TRAFFIC CIRCULATION LAYOUT

RANCHO DEL CIELO APARTMENTS

REVISION
2-4-14
FILE SET
FEB 20 2014

GRADING PLAN

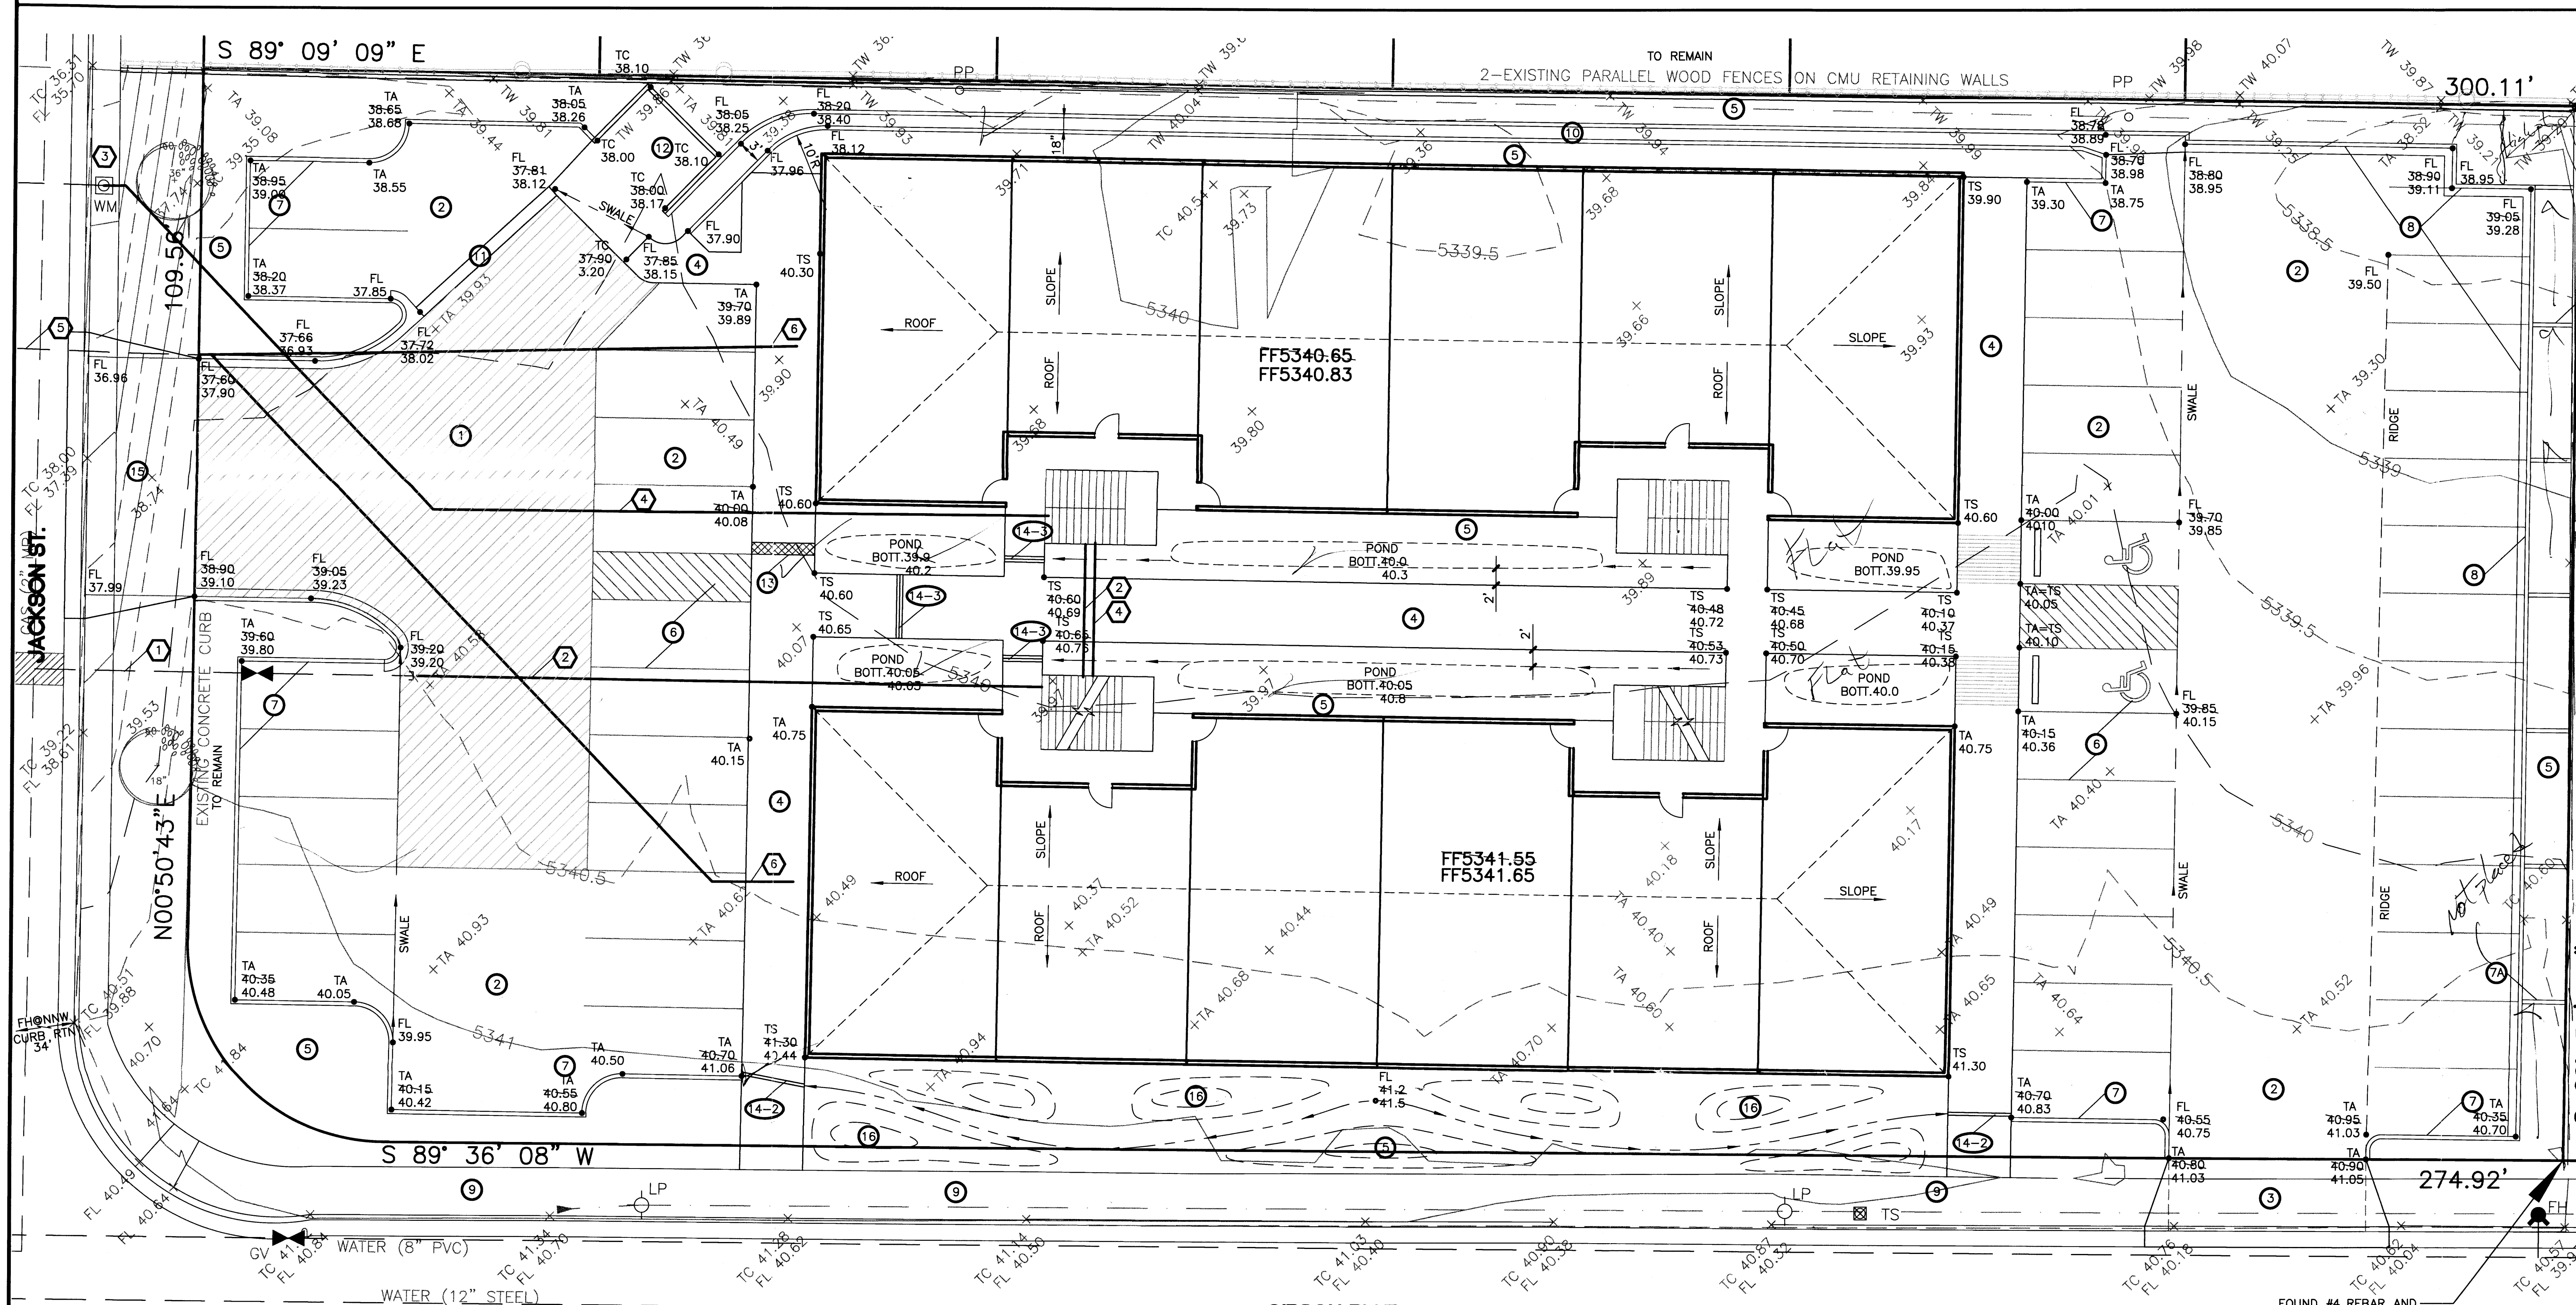
EXCEPTIONS AND/OR QUALIFICATIONS:

- THE WATER HARVESTING AREAS BETWEEN THE BUILDINGS ARE NARROWER AND SHALLOWER DU TO WIDENING OF THE STAIRS TO ACCOMMODATE MOVERS.
- THE ENTIRE PARKING LOT WAS PAVED WITH PORTLAND CEMENT CONCRETE INSTEAD OF ASPHALT CONCRETE AND IS APPROXIMATELY 0.2 FT. HIGHER THAN THE DESIGN ELEVATION.
- THE RECORD INFORMATION PRESENTED ON THE EDITED DESIGN DOCUMENT IS NOT NECESSARILY COMPLETE AND INTENDED ONLY TO VERIFY SUBSTANTIAL COMPLIANCE OF THE GRADING AND DRAINAGE ASPECTS OF THIS PROJECT. THOSE RELYING ON THE EDITED DESIGN DOCUMENT ARE ADVISED TO OBTAIN INDEPENDENT VERIFICATION OF ITS ACCURACY BEFORE USING IT FOR ANY OTHER PURPOSE.
